**SUBDIVISION REVIEW SHEET****CASE NO.:** C8-2022-0254.0A**COMMISSION DATE:** December 6, 2022**SUBDIVISION NAME:** 1191 Ridge Drive Subdivision**ADDRESS:** 1191 Ridge Drive**APPLICANT:** Tejas 1 QOZB, LP. (Gary G. Gill)**AGENT:** Southwest Engineering, Inc. (Kody Schouten)**ZONING:** SF-3-NP (single family)**NEIGHBORHOOD PLAN:** M.L.K.**AREA:** 0.52 acre (22651.2 sf)**LOTS:** 6**COUNTY:** Travis**DISTRICT:** 1**WATERSHED:** Boggy Creek**JURISDICTION:** Full Purpose**SIDEWALKS:** Sidewalks will be constructed along streets.**VARIANCE:** None**DEPARTMENT COMMENTS:**

**CITY OF AUSTIN –DEVELOPMENT SERVICES DEPARTMENT  
SUBDIVISION APPLICATION – MASTER COMMENT REPORT**

PROJECT NAME: 1191 Ridge Drive Subdivision  
 LOCATION: 1191 Ridge Drive

EXHIBIT B

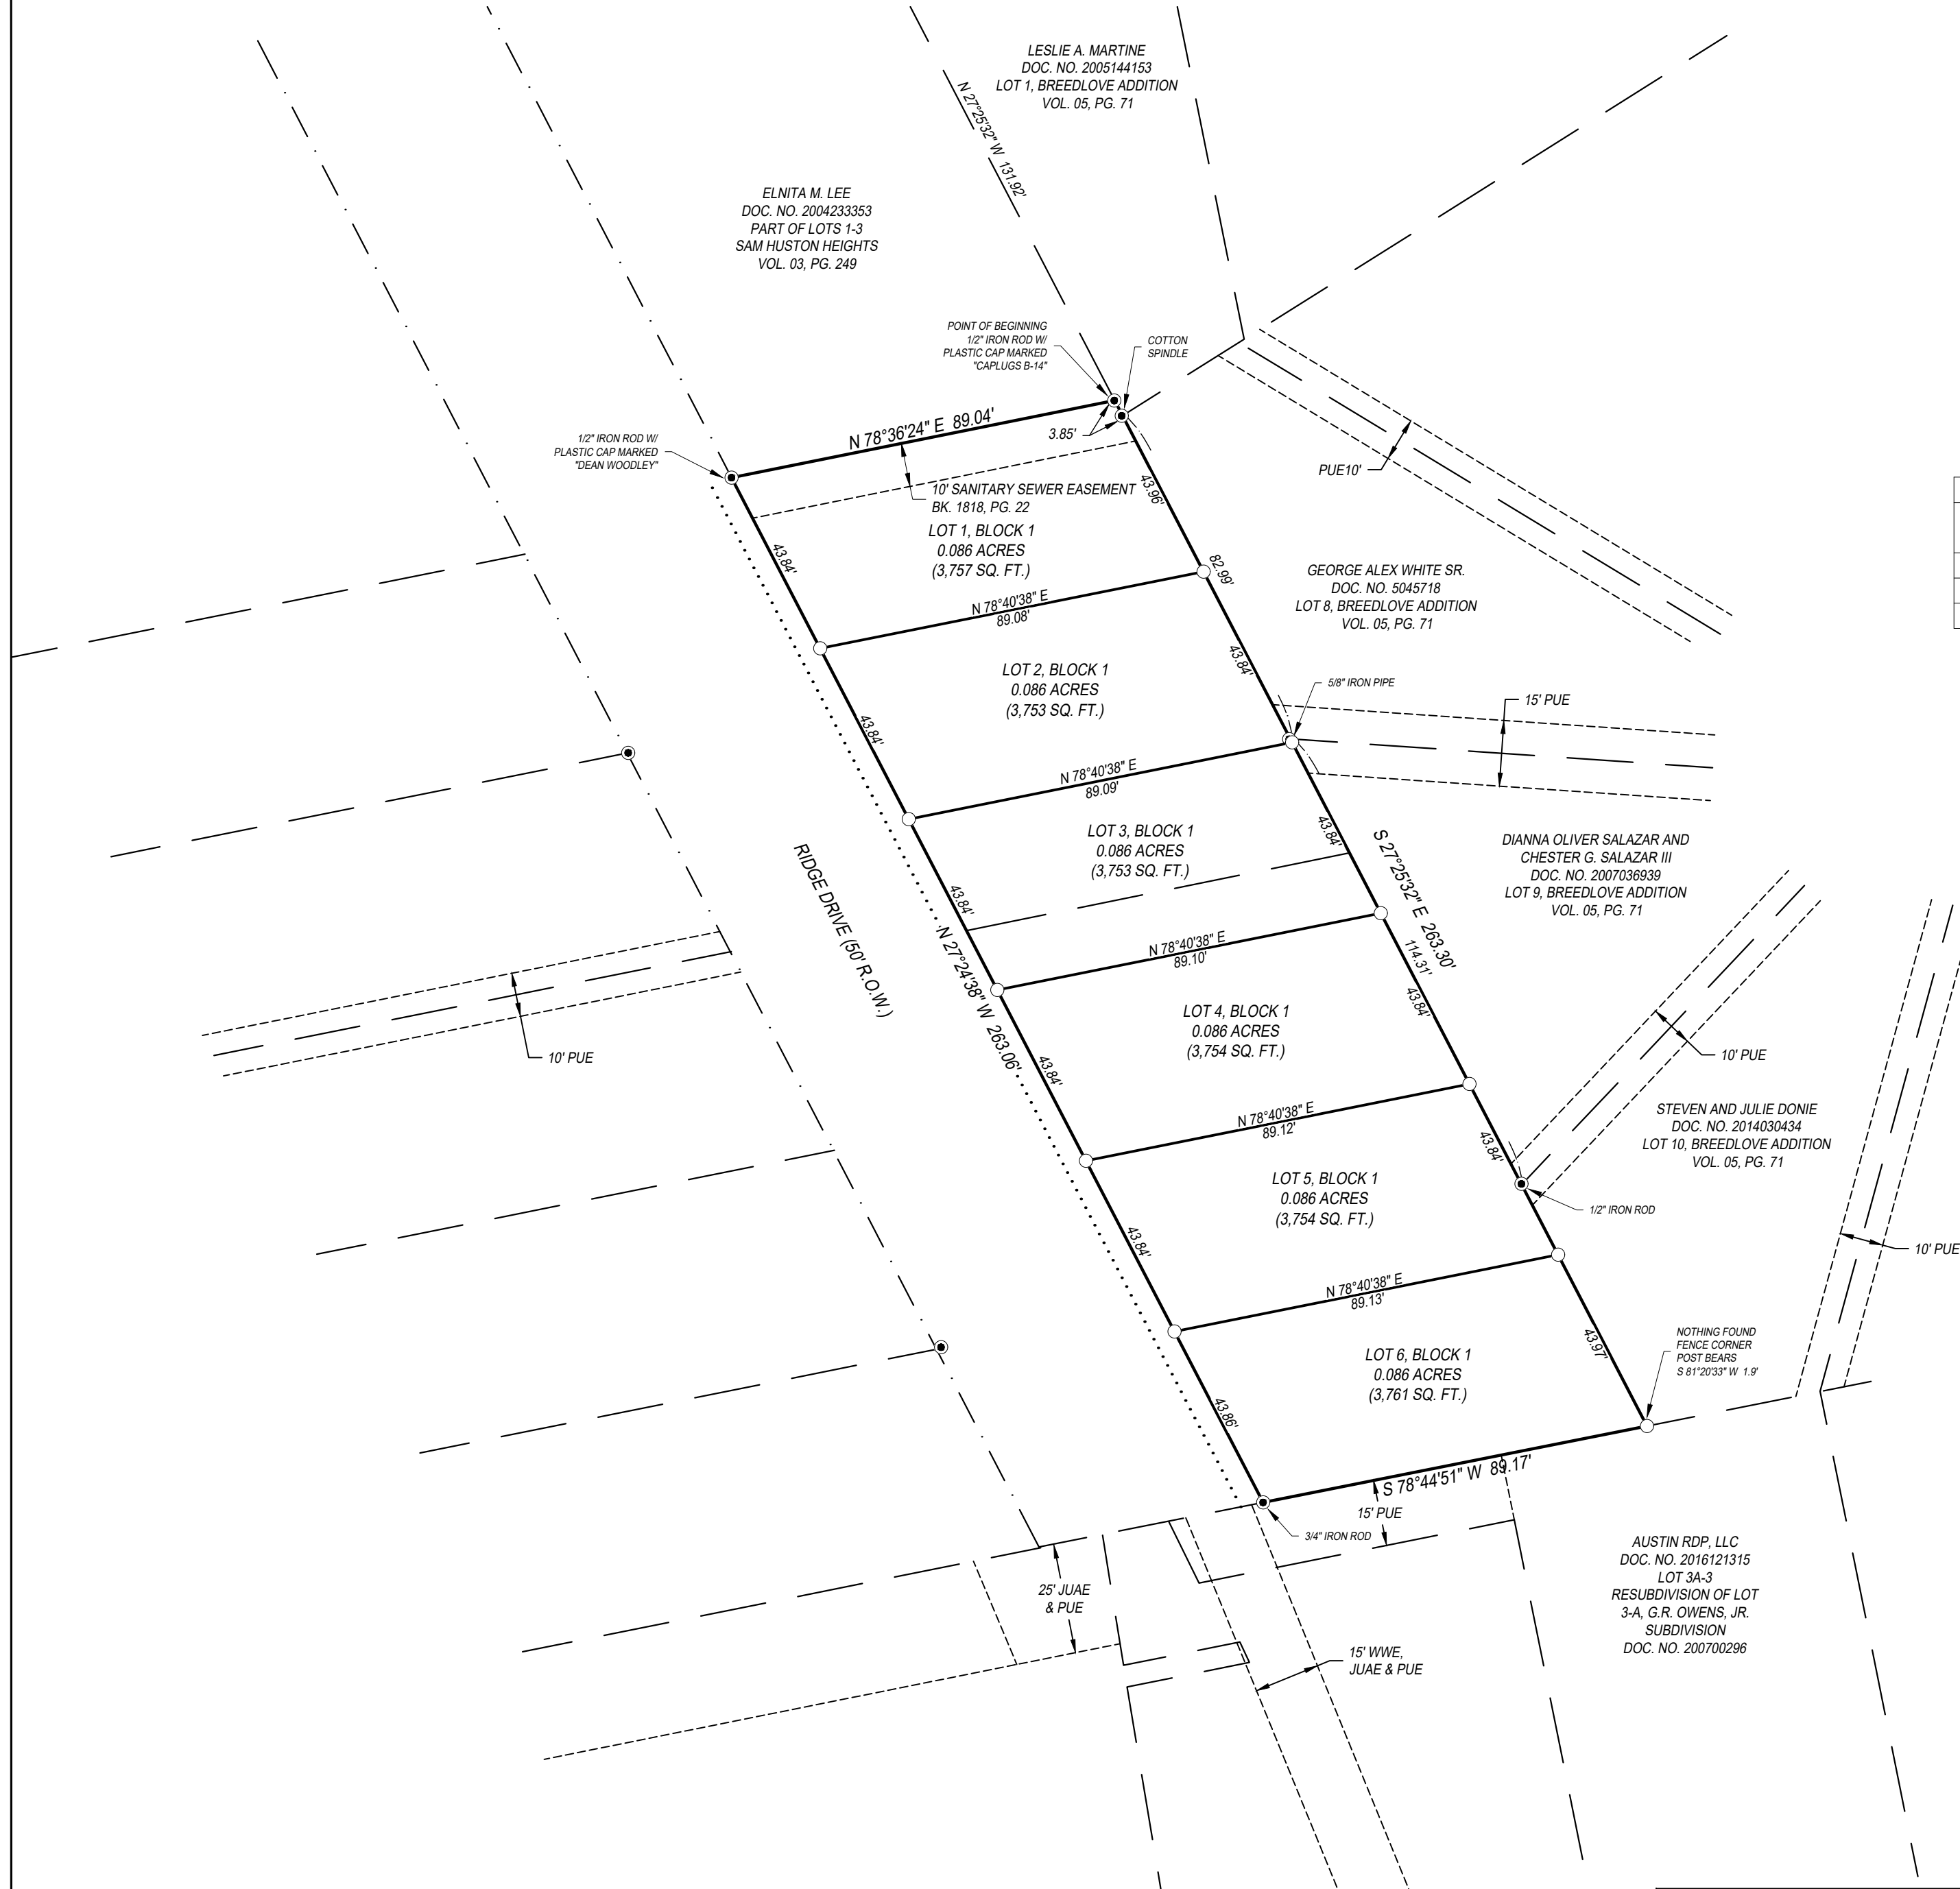
SR 2. On the plat inside Lot 3, remove the dashed line. Or, annotate accordingly if the dashed line is showing an easement or other property feature. LDC 25-1-83, 30-1-113

SR 3. Add the case number on the lower right margin of each sheet, C8-2022-025.0A . LDC 25-1-83, 30-1-113

SR 4. Verify the scale on plat is correct to avoid amending the plat during the residential or site plan phases. LDC 25-1-83, 30-1-113

SR 5. Provide Lot Summary Table, the table should include lot acreages, square footage, and totals. LDC 25-1-83, 30-1-113

Ten-foot electric distribution, electric telecommunications, and electric fiber easement is required adjacent to Ridge Dr R.O.W. Show the easement(s) on the face of the plat.

ATD 3. ASMP calls for 58 feet of right-of-way for RIDGE DR. Dedicate 29 feet of right-of-way from the existing centerline along RIDGE DR in accordance with the Austin Strategic Mobility Plan (ASMP) [LDC 25-6-51 and 25-6-55].

Please, show the joint use access easements on the plat (if proposed).

A joint-use driveway used as alternative access for a single-family residential use may serve not more than eight dwelling units. LDC 25-6-451(C). Provide a plat not restricting the number of dwelling units accessing the single joint use access easement driveway.

ATD 5. Remove the plat note # 12. The proposed lots do not abut SHERWOOD RD and FOREST WOOD DR.
